Access Compliance Report Public Rights-of-Way (Curb Ramps)

Intersection ID: 14225Main Street: N_CASWELL_RDCross Street: VAIL_AVLocation:SWADA ID: ED2FCE70C432Ramp Type: PerpInitial Pass/Fail: FailOverall Compliance: NoSeverity Score:25

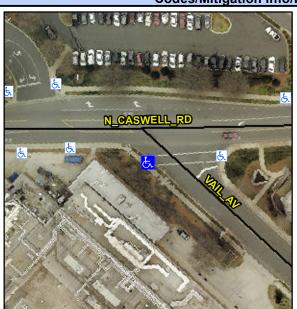
Possible Solutions:	Com
Remove & Replace Entire Ramp.	N/A
·	Yes
	N/A
	N/A
	N/A
	N/A
Surveyor Notes:	N/A
N/A	N/A
	N/A
	N/A
	N/A
PROW/ADA:	N/A
Not Found, R304.2.2, R304.5.3	N/A
	N/A
	N/A

Compl	iance Description	Data		liance Description	Data
N/A	Ramp Length (in)	100.0	No	Ramp Slope (%)	9.4
Yes	Ramp Width (in)	48.0	No	Ramp XSlope (%)	5.6
N/A	Flare Type LT	N/A	N/A	Flare Type RT	N/A
N/A	Flare Slope LT (%)	N/A	N/A	Flare Slope RT (%)	N/A
N/A	Flare Traversable LT?	N/A	N/A	Flare Traversable RT?	N/A
N/A	Landing Length (in)	N/A	N/A	DWS Provided?	N/A
N/A	Landing Width (in)	N/A	N/A	DWS Contrast?	N/A
N/A	Landing Slope (%)	N/A	N/A	DWS Length (in)	N/A
N/A	Landing X Slope (%)	N/A	N/A	DWS Full Width?	N/A
N/A	Landing Curb? (Y/N)	N/A	N/A	DWS Offset (in)	N/A
N/A	Shared Landing?	N/A			
N/A	Gutter Ponding?	N/A	N/A	Gutter Slope (%)	N/A
N/A	Gutter Lip Ht (in)	2.0	N/A	Gutter X Slope (%)	N/A
N/A	Painted X Walk1?	Yes	N/A	Painted X Walk2?	N/A
	X Walk 1 Direction	To E		X Walk 2 Direction	N/A
N/A	X Walk 1 Width (in)	112.0	N/A	X Walk 2 Width (in)	N/A
	X Walk 1 Slope (%)	4.3		X Walk 2 Slope (%)	N/A
	X Walk 1 X Slope (%)	2.2		X Walk 2 X Slope (%)	N/A
